Please consider the following my submission to the scoping process for the Tessera Solar 1 [08-AFC-13] development project.

08-AFC-13

Proposed Action - West Mojave Route Designation Program

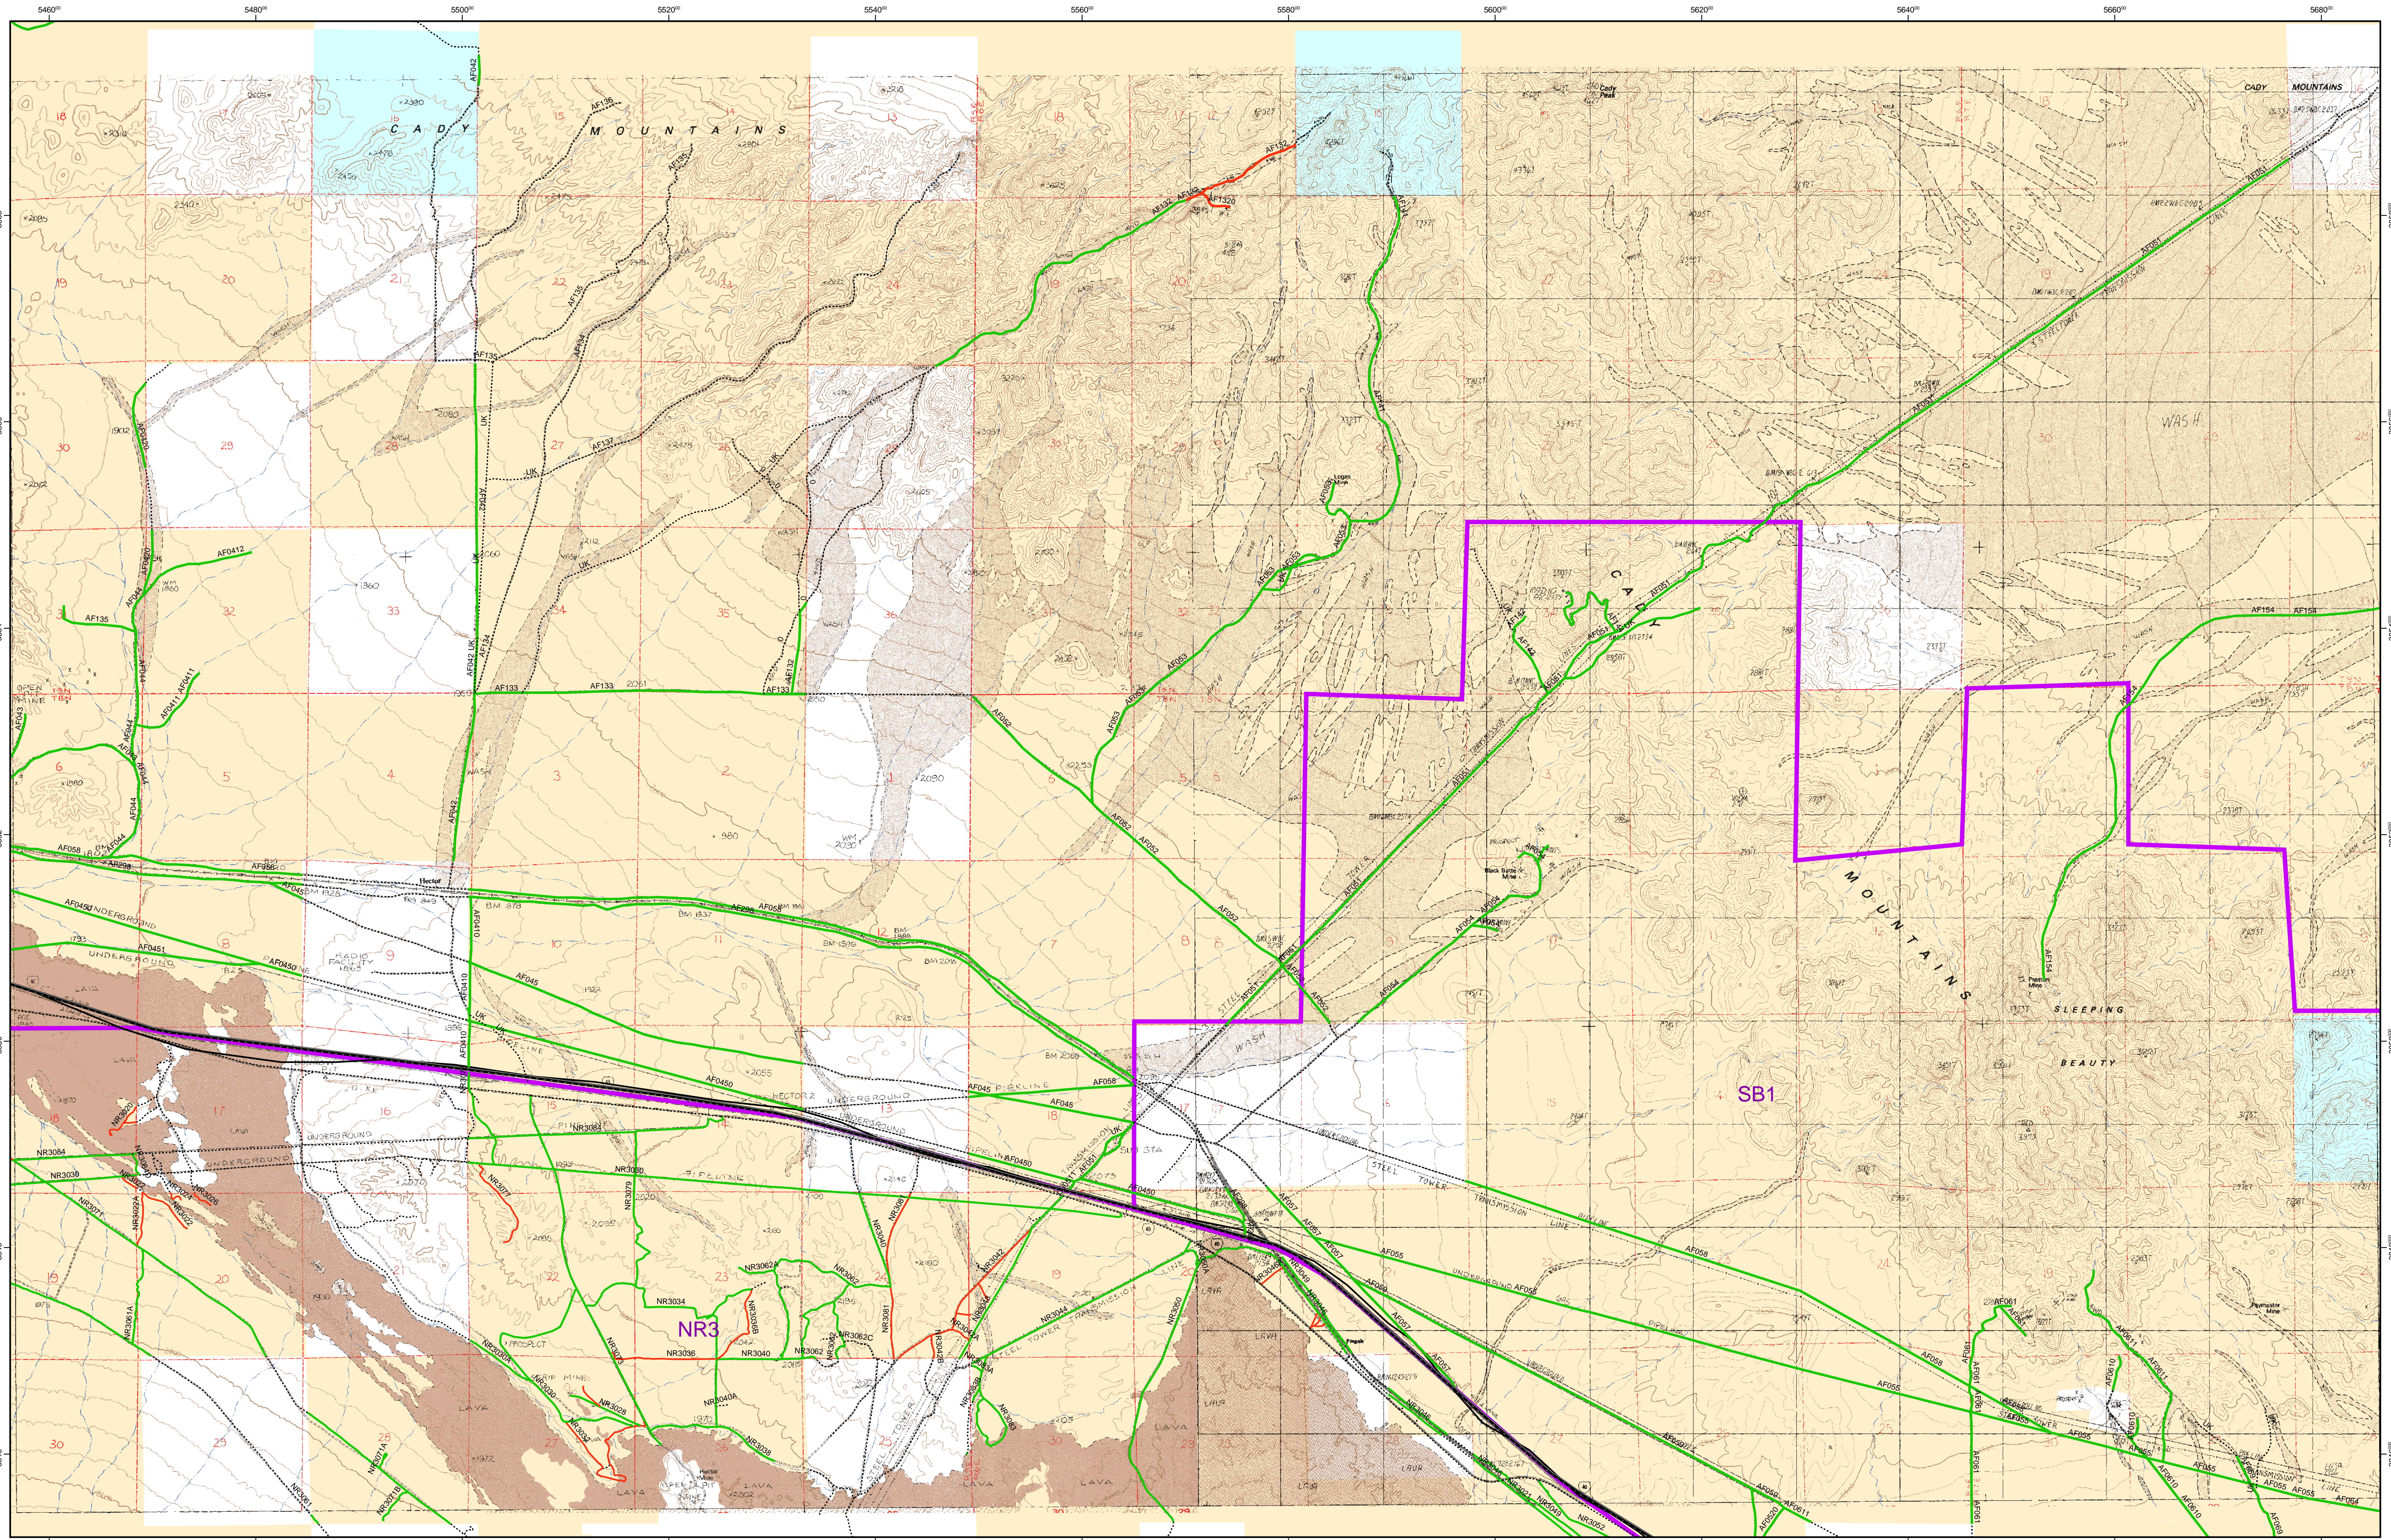
3. If you look at the BLM WEMO map (FEIS_pr_55) which is included with this email, you'll see that the road network in this area has been documented. Should the project be built, not only will access to the guzzler be blocked, wildlife habitat will be lost or negatively affected, but as well a large network of roads and access to certain parts of the Cady mountains will be lost. This loss will not only cause wildlife to suffer but as well will eliminate recreation opportunities in the area affected. My question and request is, "How will Tessera and the government agencies involved mitigate these losses?"
